W/C RAMP RAIL REWORK

Property and Top Bus Number: DART: 304500

Issue: W/C ramp rails contacting frame of bus causing ramp to not fit properly

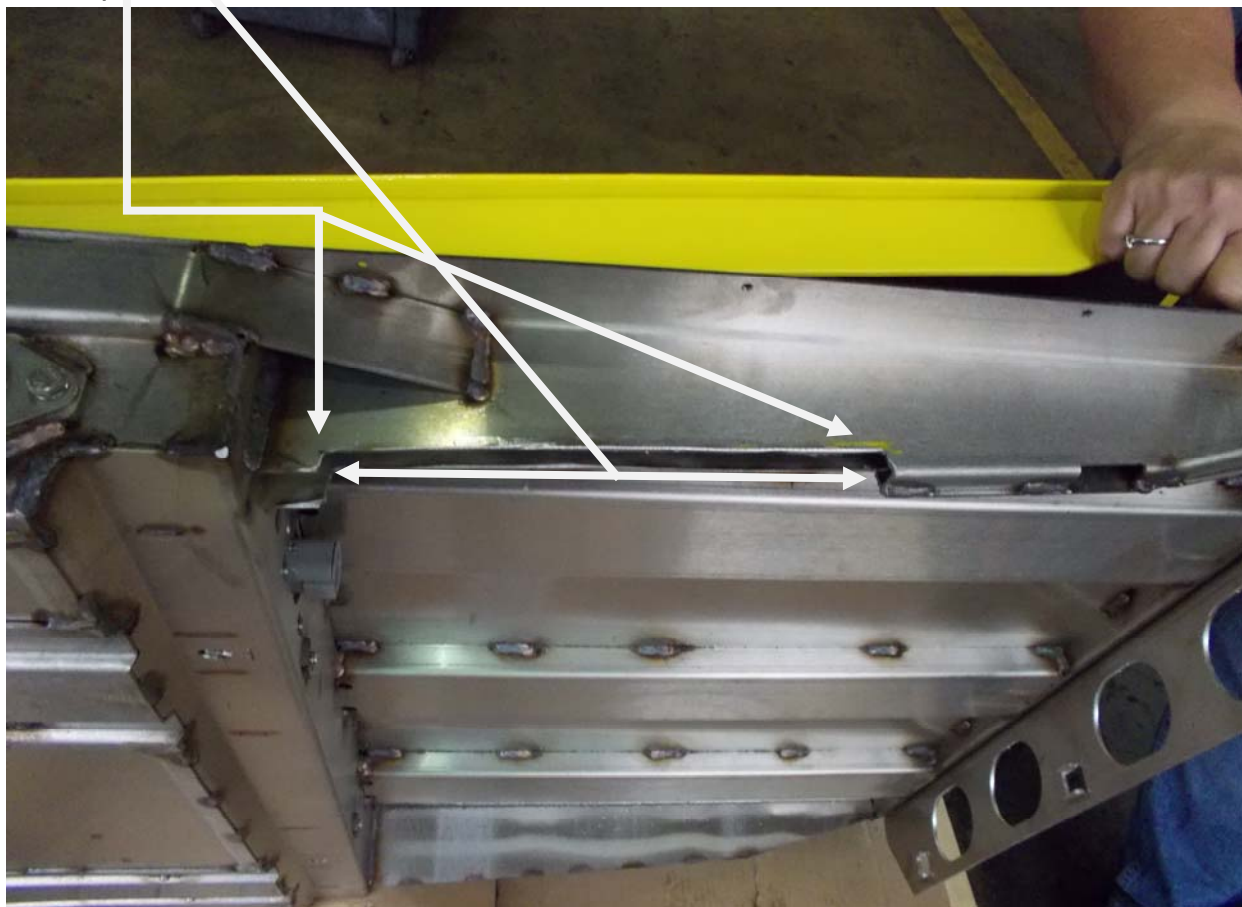
Reason/ cause: Ramp rail is contacting the bus frame

Solution: Notch ramp to allow proper fit

1. Park the bus and apply the parking brake.
2. Turn off main battery disconnect switch(es).
3. Unplug ramp harness and remove the mounting hardware (6x)
4. Slide ramp back far enough to rework
5. Cut ramp on both sides with die grinder and debur all sharp edges as illustrated in the picture below

8.35" wide
.5" deep

6. Reinstall ramp and hardware. Shim as needed.
7. Torque to 30 - 44 ft. lbs.(depends on wet or dry torque)
8. Reconnect ramp harness
9. Check for completeness of work.
10. Remove all tools from work area.
